**Wickenburg Downtown Flooding Hazard
Mitigation Project
(FCD #2006C018)
CLOMR
FEMA Case No. 07-09-0738R**

**Response to
FEMA Review Comments of
April 17, 2007**

IN REPLY REFER TO:
Case No.: 07-09-0738R

Comment #2

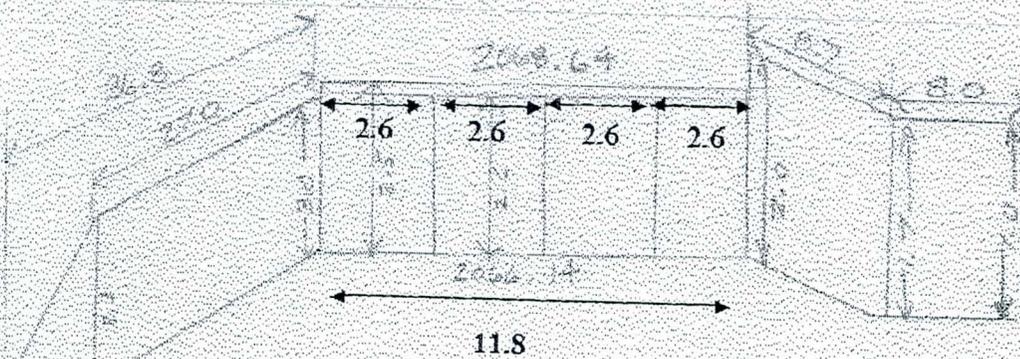
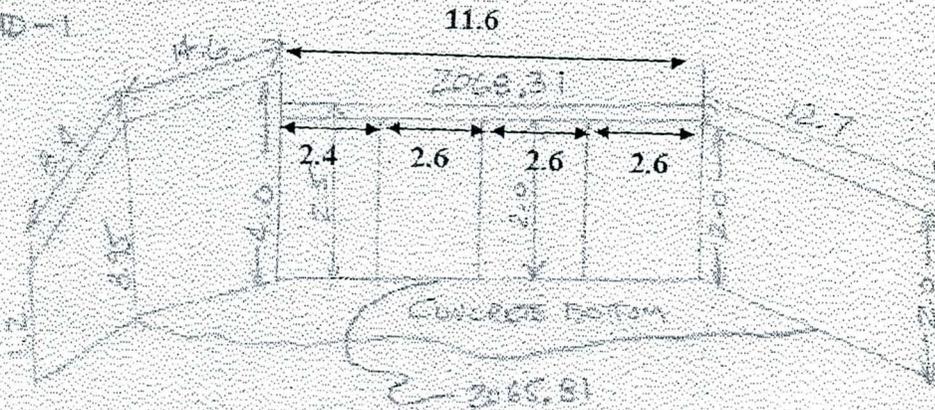
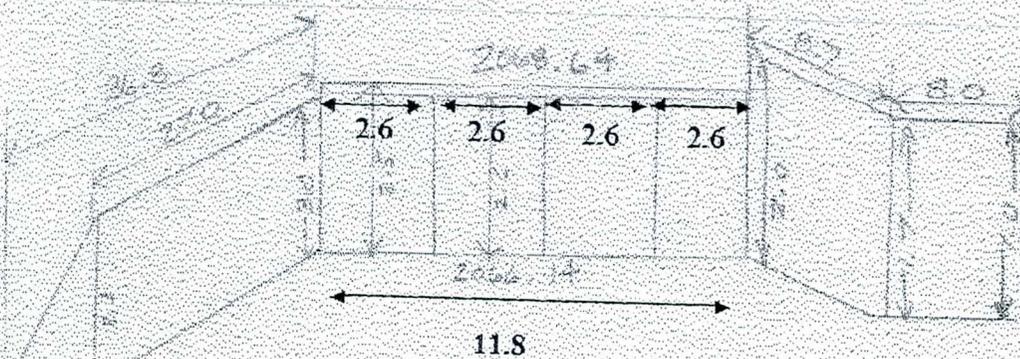
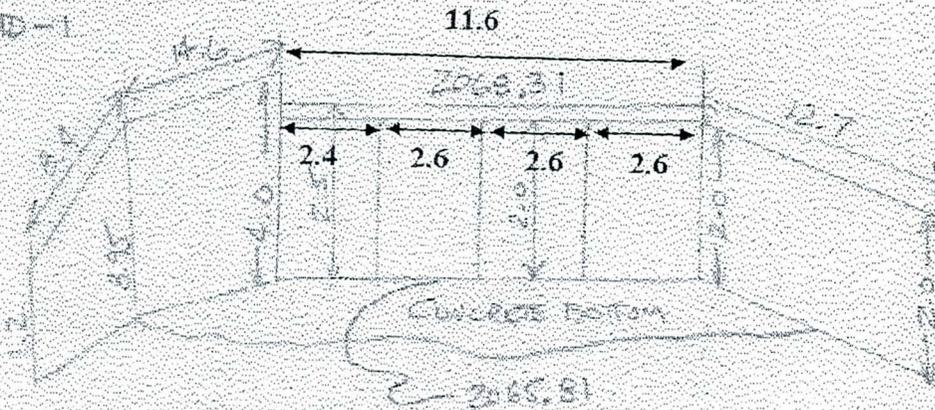
2. Please provide survey data or as-built information, certified by a registered professional engineer, for the existing Cavaness Avenue crossing over Hospital Wash.

FCDMC Contract 2003C050
 Task 9 Sols Wash Survey
 Structure Detail Worksheet
 SW Mapping Project 05-0031

Comment #6

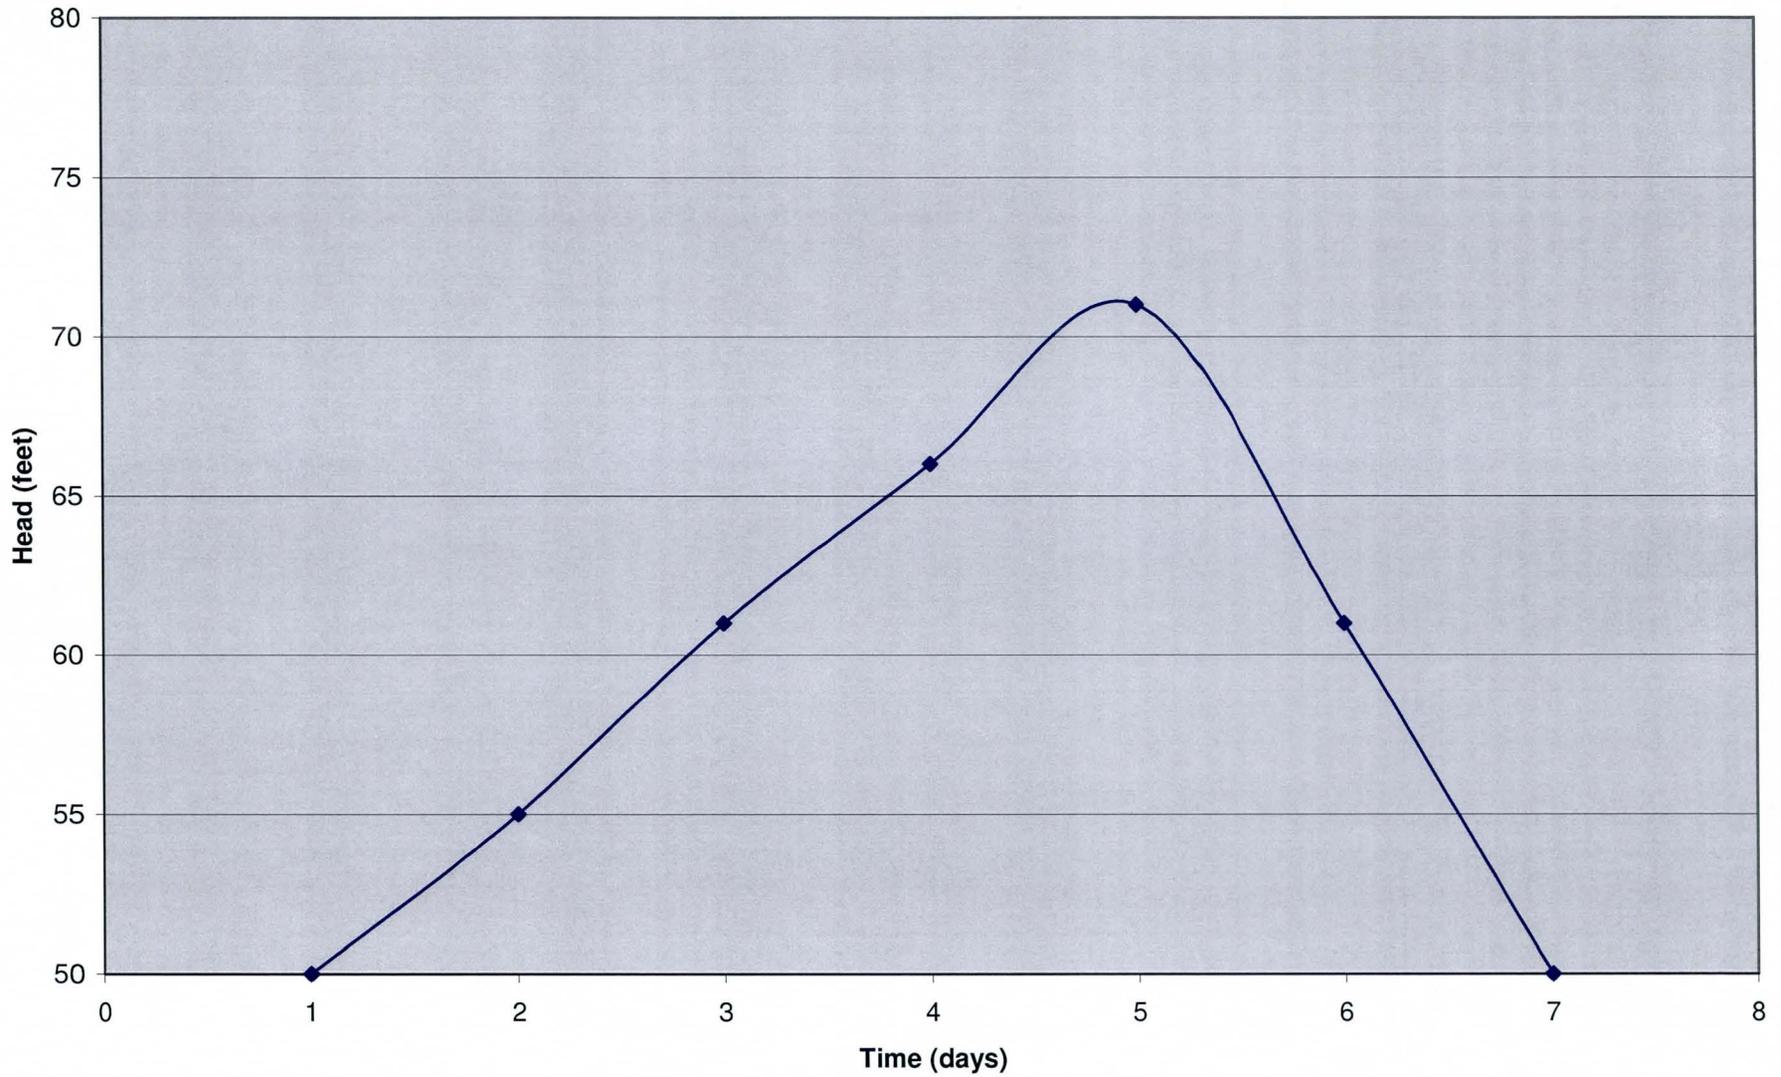
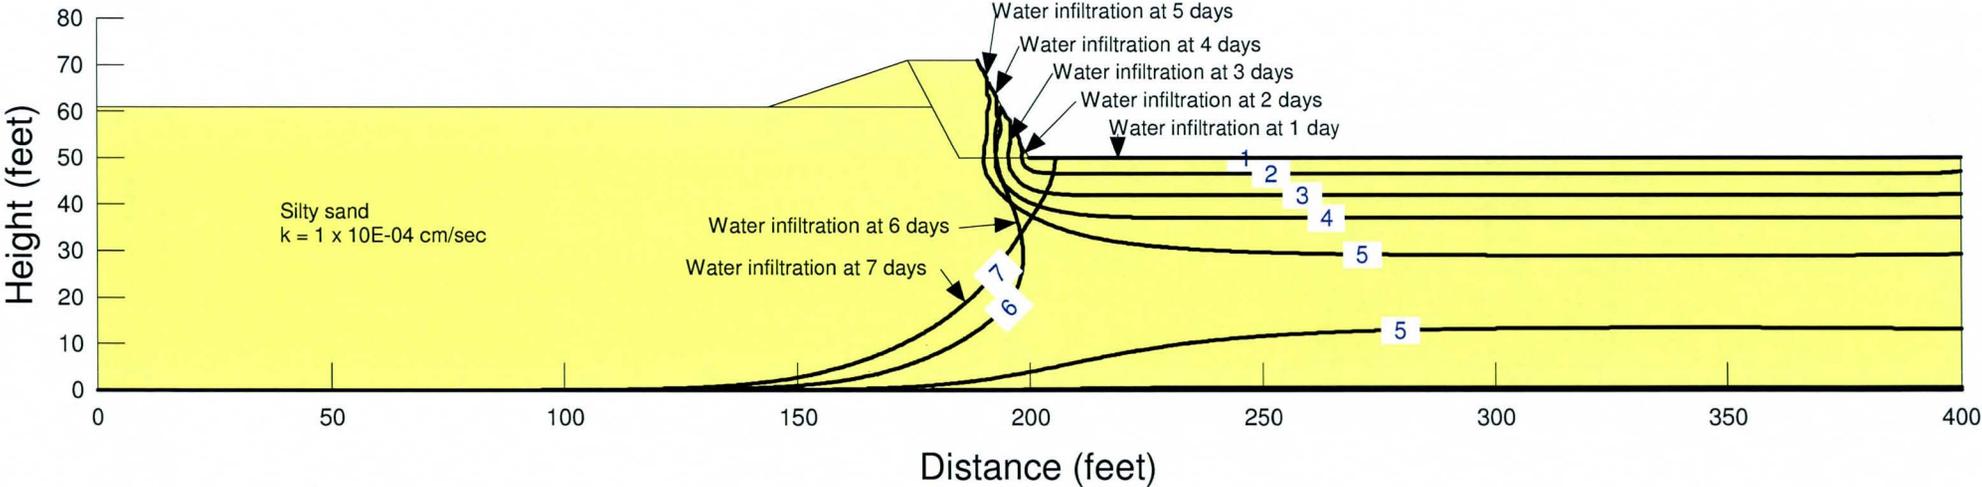
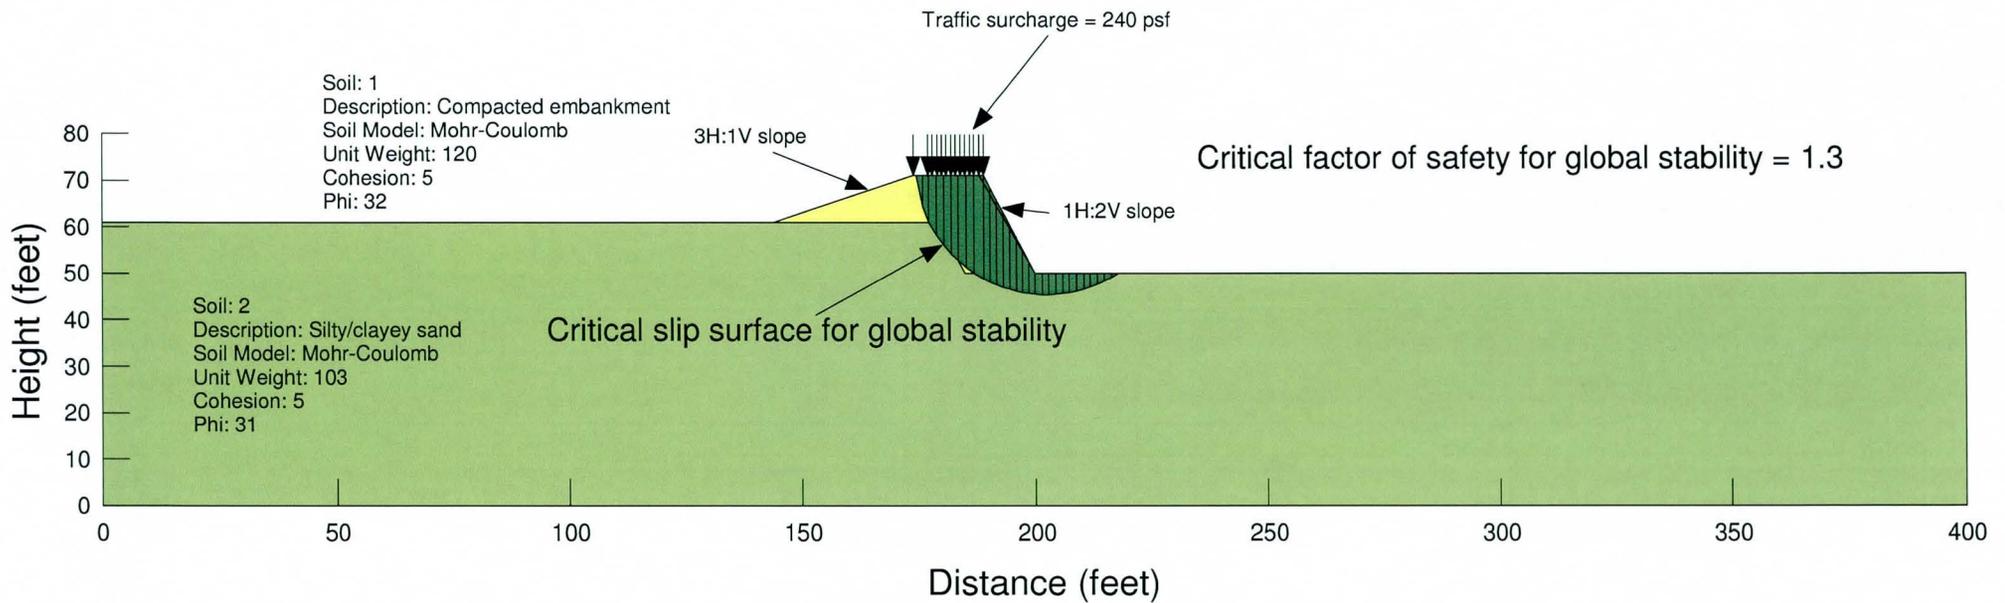
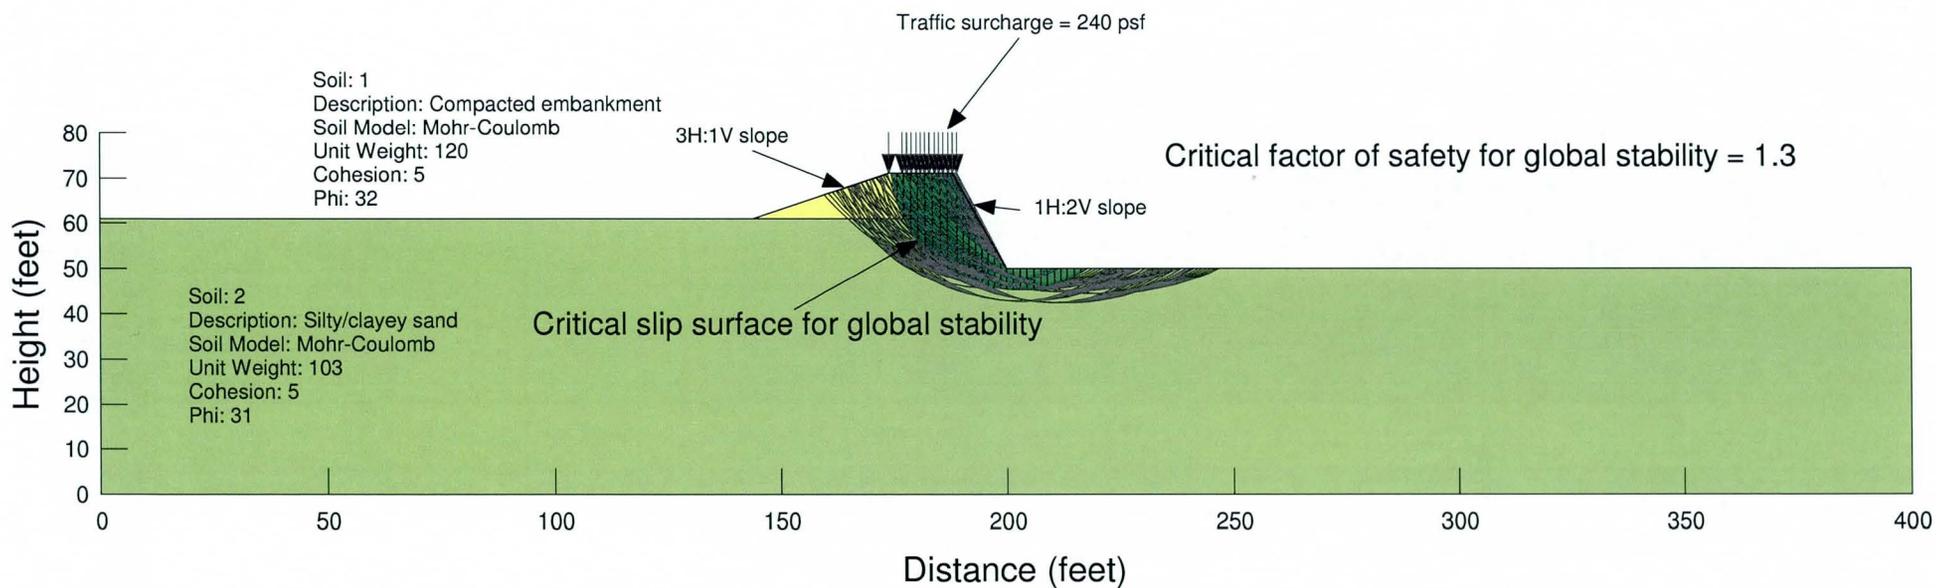
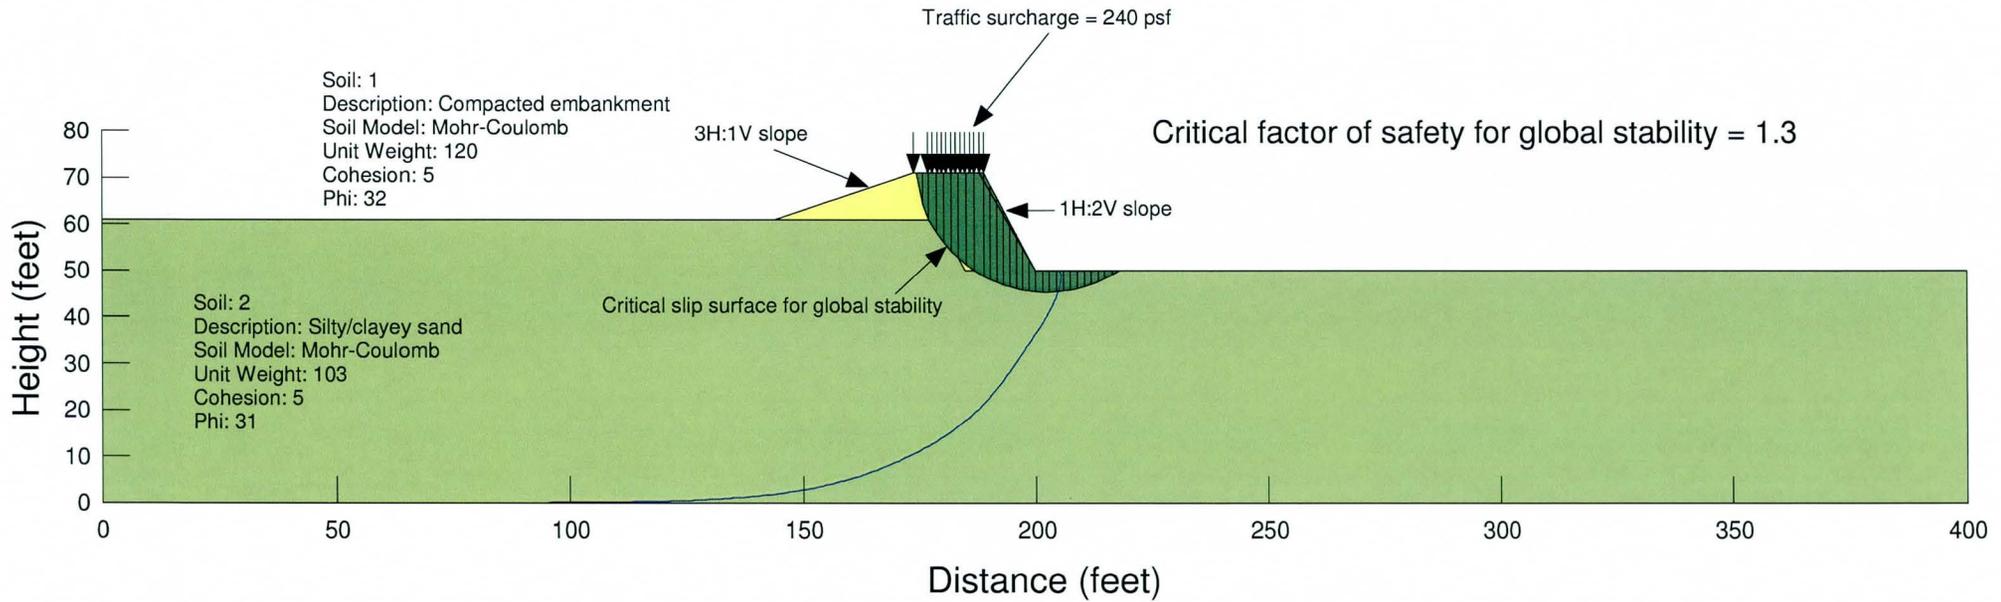
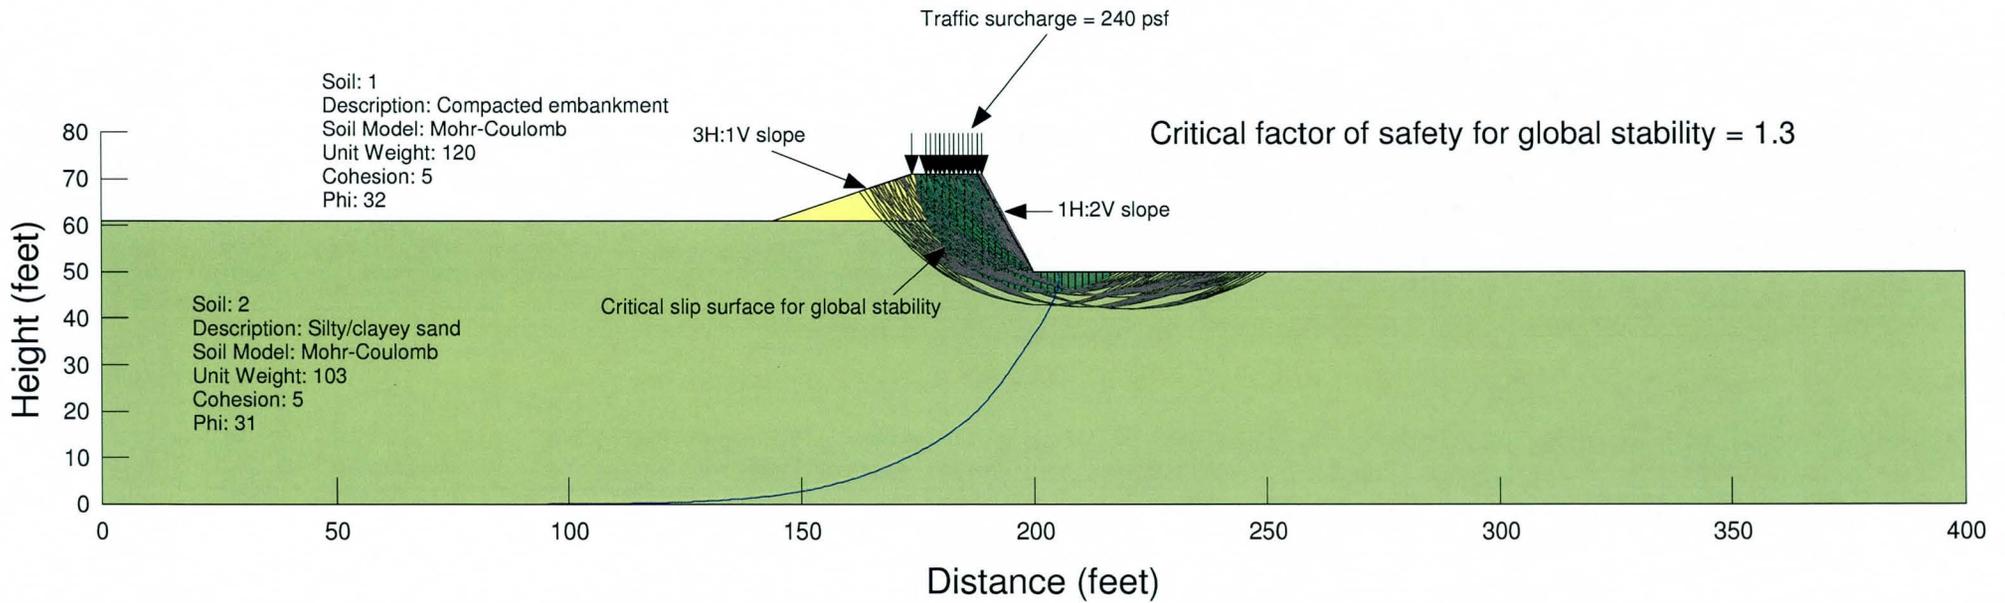
7. Please submit the specifications for the levee and structural fill, including material types, placement, moisture content and percent compaction.
8. The Special Flood Hazard Area (SFHA), the area that would be inundated by the base (1-percent-annual-chance) flood, designated Zone AO is subject to shallow flooding, usually sheet flow on sloping terrain, with average depths between 1 foot and 3 feet. This zone designation is typically not used on the overbanks of Zone AE flooding. Please change the Zone AO to Zone AE on the submitted maps entitled "Sols Wash CLOMR", panels 1-10, prepared by Engineering and Environmental Consultants, dated December 2006, or explain why this is not necessary.

The nominal value of 5 lb/ft² used in the stability analyses was assumed for cohesion of the generally silty granular materials found at the site to correctly model the effect of embankment height (GEO-SLOPE International, Ltd., 2002).

The seepage analysis consisted of performing a transient analysis of river conditions based on a conservatively assumed hydrograph. The HEC-1 hydrograph developed for the project indicated that flow in the normally dry river could be expected to reach a maximum in a period of several hours, with the water receding over a period of 8 to 10 hours. To simulate an assumed worst-case condition where
